Beaver Creek Coal Company  
P. O. Box AU  
Price, Utah 84501  
Telephone 801 637-5050

Re: Castle Valley Spur  
ACT/007/022

Enclosed please find three (3) copies of a proposed minor modification to our C.V. Spur Mining and Reclamation Plan. The changes are required because of increasing coal inventories and the need to stockpile raw coal for shipment in 1983.

SECTION A-A'

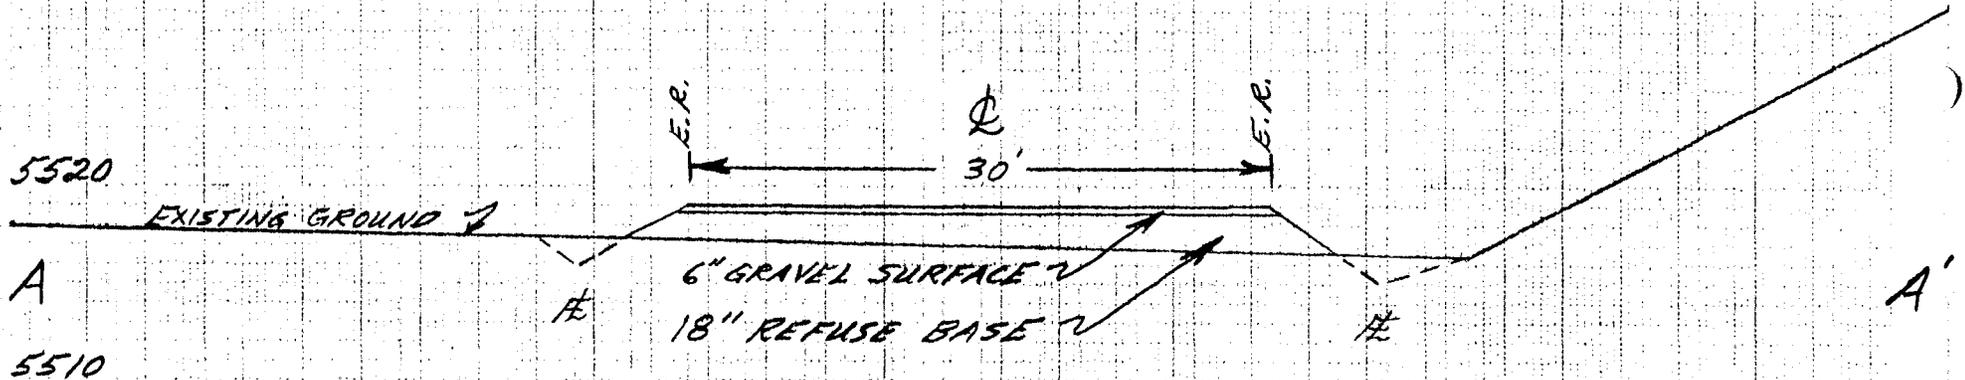
The modification consists of the addition of a new haul road and raw coal stockpile area along with a change in two (2) sedimentation ponds. The new haul road is proposed to run just west of the newest truck dump and will tie into the existing refuse haul road. This road will be widened to accommodate two-way traffic and will provide access to the stockpile area. The proposed stockpile area is just south and east of the reclaim control house and silo conveyor, in the area of sediment pond #4. It is proposed to eliminate pond #4, and provide the identical capacity by enlarging pond #5. These proposed changes and cross-sections are shown on the attached maps.

It is further proposed to build the sub-base of the haul road and the stockpile pad out of compacted refuse. The road will be capped with gravel, and the stockpile pad will have a layer of reject coal fines over the sub-base material. The pond will also be filled with refuse, compacted in 18" lifts, and covered with a 12" minimum layer of clay material to seal it from water or air infiltration. The refuse has been shown to be non-toxic and to
